ADDENDUM NO. 1

May 10, 2022

Silver Creek School District – Athletics Package and Steel & Roofing Package
Sellersburg, IN 47172

1 EXISTING HOME BLEACHERS
A205 SCALE: 1/8" = 1'-0"

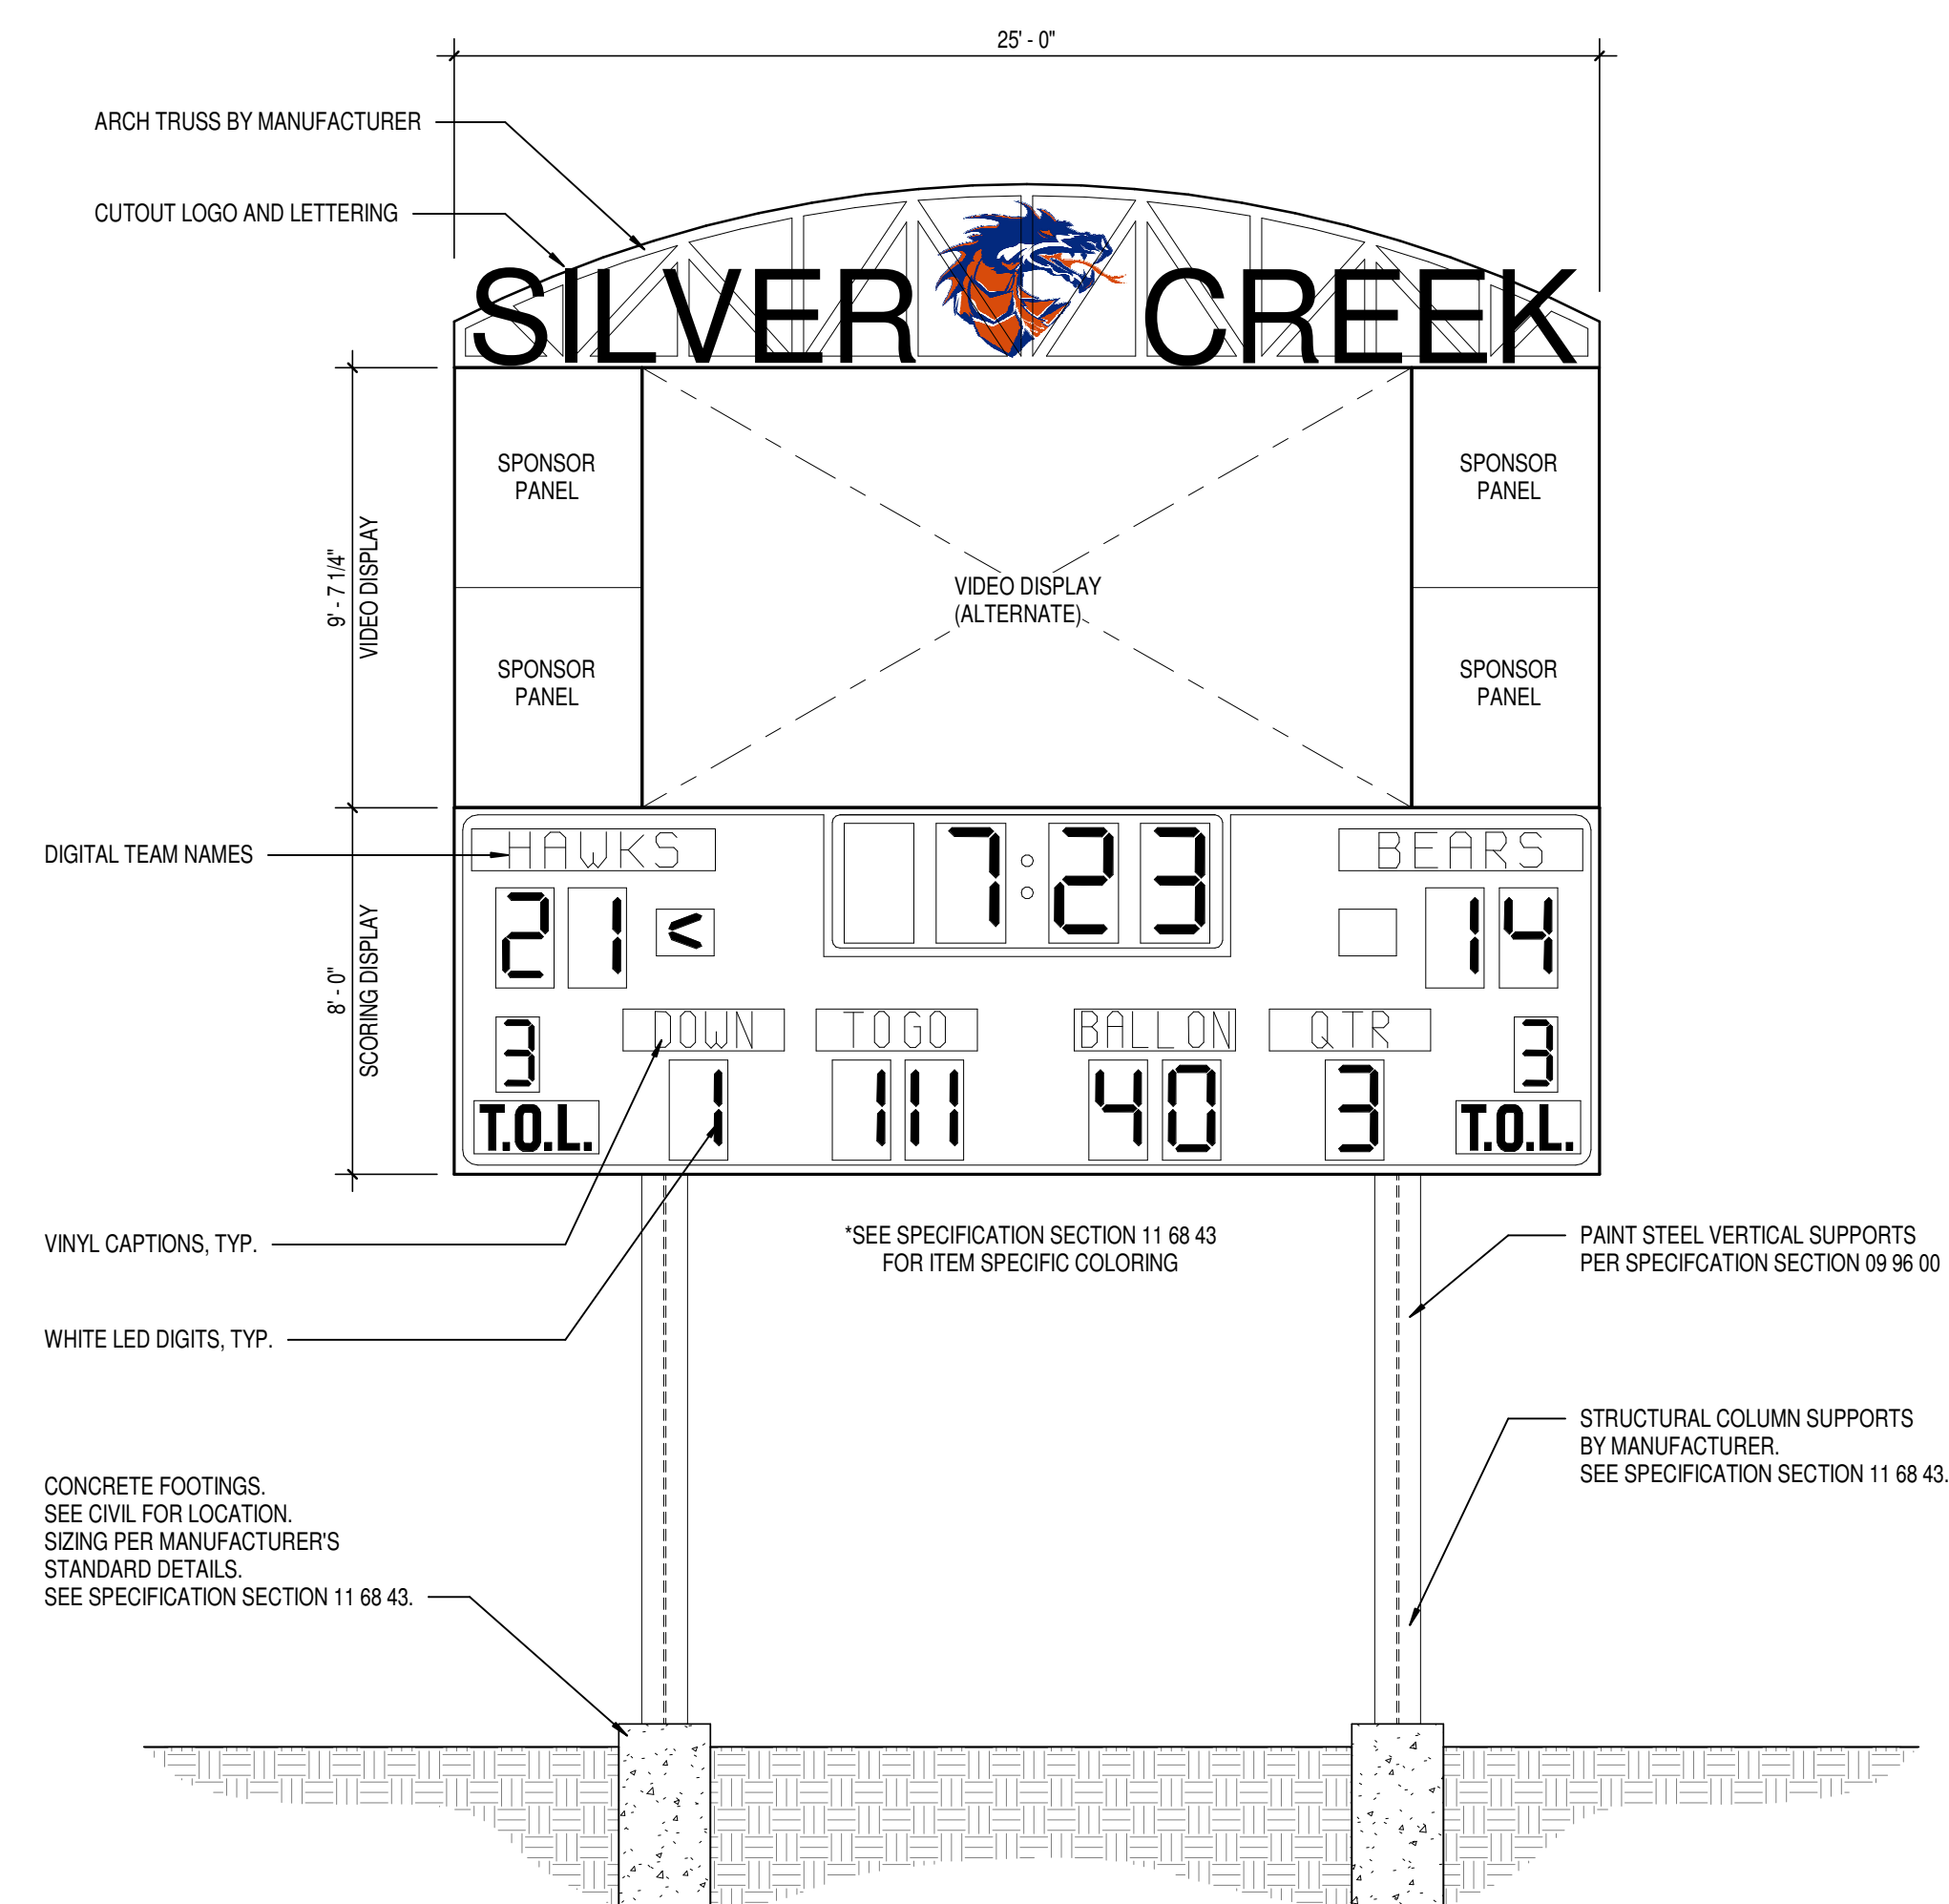
- ☐ REVISE NOTE ON 1/A205 – “EXISTING PRESSBOX TO BE REMOVED AND SALVAGED. RETURN TO OWNER”
